Access Compliance Report

Public Rights-of-Way

Intersection ID: 46146	Main Street: ROCKY_FORD_CLUB_RD	Cross Street: BEAVER_CREEK_DR	Location: NW
ADA ID: 7679A8FD76F4	Ramp Type: BlendTrans1	Initial Pass/Fail: Fail	Overall Compliance: No
Severity Score: 8.75			
Codes/Mitigation Info/Possible Solution		Field Measurements/Component Compliance

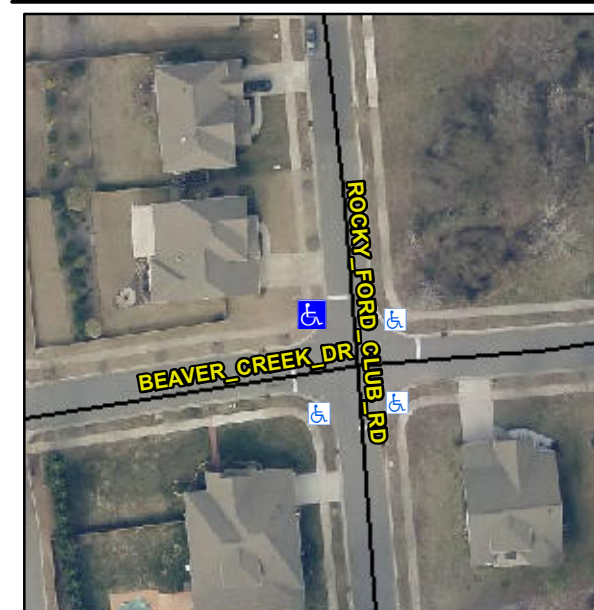
R304.5.1

Remove & Replace Curb Ramp With Two New Directional Ramps or Equivalent.
